City of Surrey
PLANNING & DEVELOPMENT REPORT

Application No.: 7922-0187-00

Planning Report Date: July 10, 2023

to permit the development of a 6-storey apartment building with approximately 109 dwelling units and underground parking on a consolidated site in Guildford.

DRAWING TITLE:
SOIL VOLUME PLAN

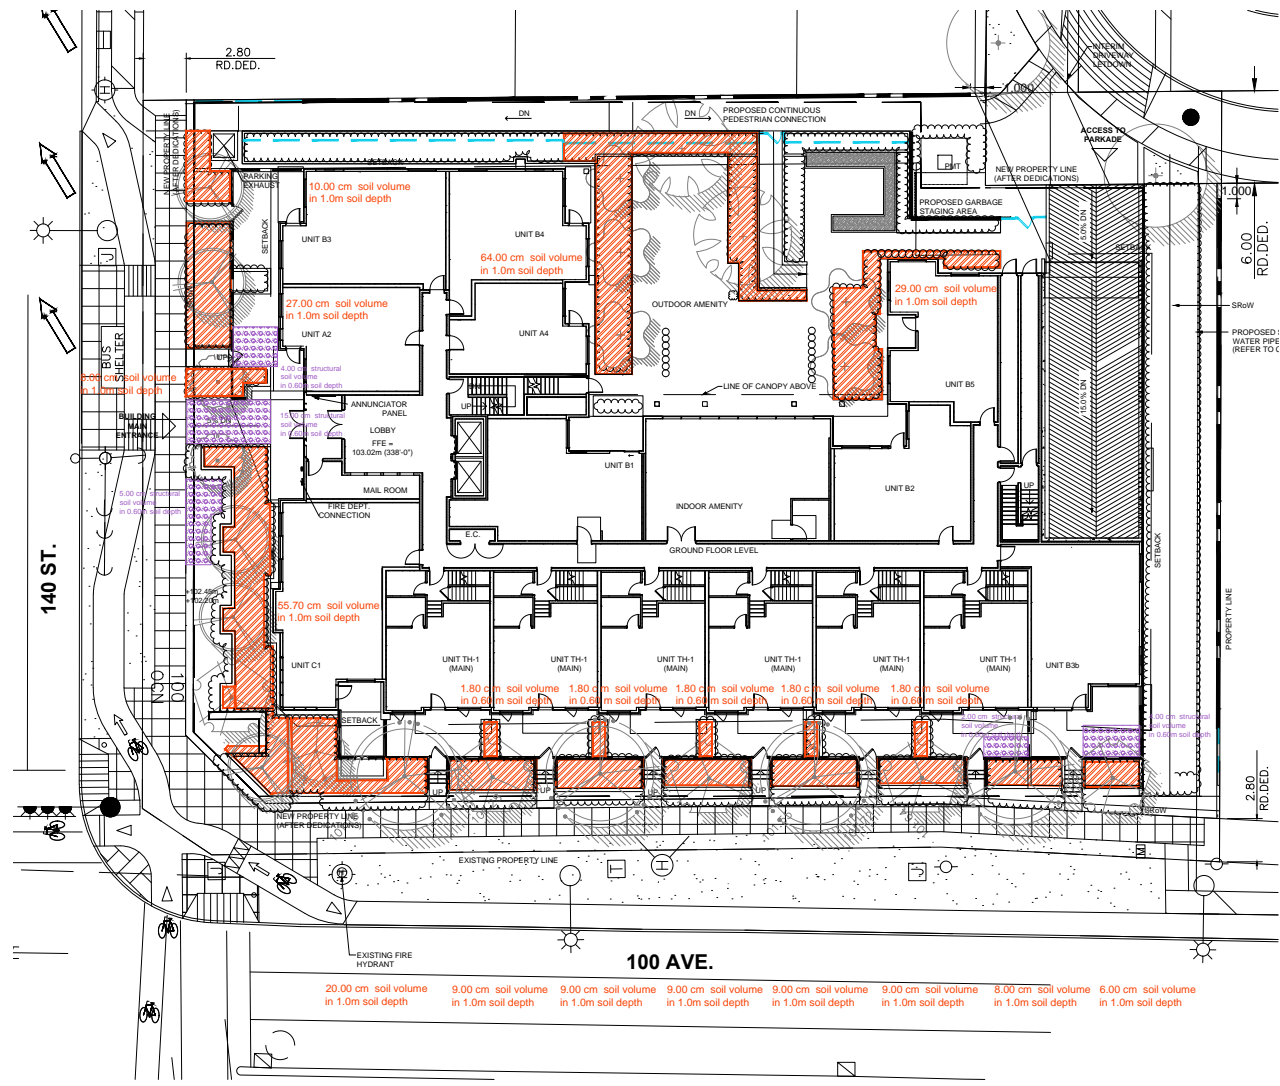
- Consider having soil volumes identified in tree planting areas.
